IMPORTANT SAFETY RECALL

Bulletin Number: NHTSA Recall 21V272/Transport Canada Recall 2021-258

Product Line: 2021 Airstream Interstate 19

Subject: Incorrect Breaker Terminal Wiring

Figure 1

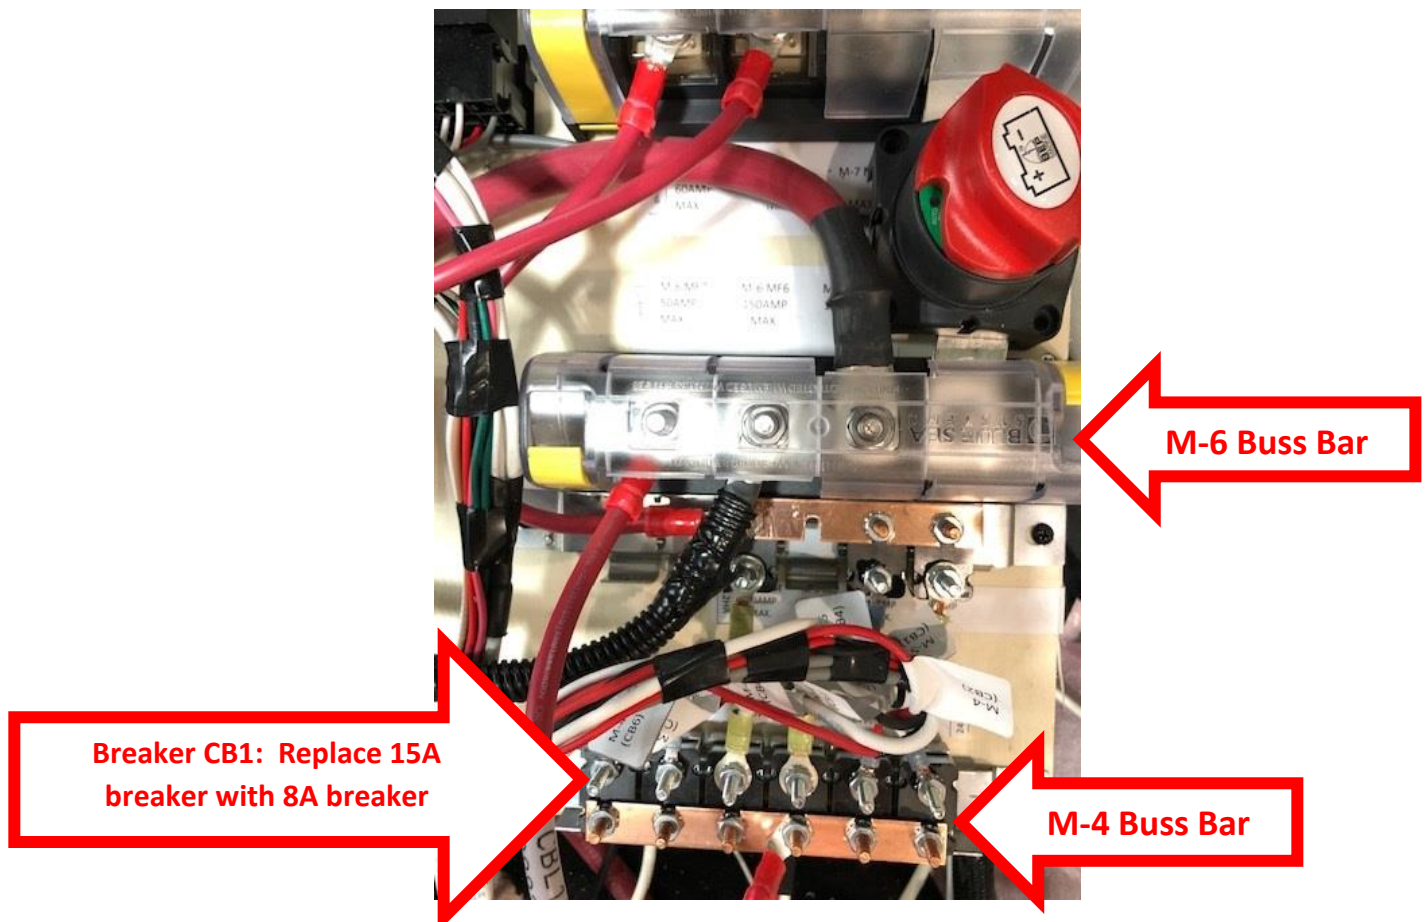
Airstream has discovered that the Sony radio power circuit on certain Interstate 19 motorhomes was incorrectly sized at 15A. The wire size in the body harness is 16 AWG, which is undersized for the 15 A breaker. In an overcurrent situation, the 16 AWG wire could melt and cause a fire. The circuit breaker will need to be replaced with the correct size of 8A.

3. Disconnect CBL 18 (8 Ga. Red wire) from the M-4 buss bars upper CB4 location (see Figure 1). Tape off the connector end to prevent this wire from short circuiting. (CBL 18 is a 12VDC live wire coming from the 24-hour power, located on buss bar M-6).
4. Disconnect the solar power wire M4d (8 Ga. Red wire) from the M-4 buss bars lower CB4 location. Tape off the connector end to prevent this wire from short circuiting.

5. Remove the radio breaker CB1 (15A) and replace it with the new 8A circuit breaker. Torque the nut to 24 in/lbs.
6. The correct breaker sizes are as follows:
 - a. CB1 – Radio Power: 8A
 - b. CB2 – 24-hour Power: 8A
 - c. CB3 – Macerator Pump/Dump Valves: 20A
 - d. CB4 - Solar: 40A
 - e. CB5 – Main Disconnect: 6A
 - f. CB6 – Waste Hose Reel: 15A
7. Remove the tape from CBL 18 and reconnect the cable to the top of the CB4 breaker. Torque the nut to 24 in/lbs.
8. Remove the tape from wire M4d and reconnect the wire to the bottom of the CB4 breaker. Torque the nut to 24 in/lbs.
9. Print out and affix an updated label over the existing label.
10. Reassemble the enclosure.
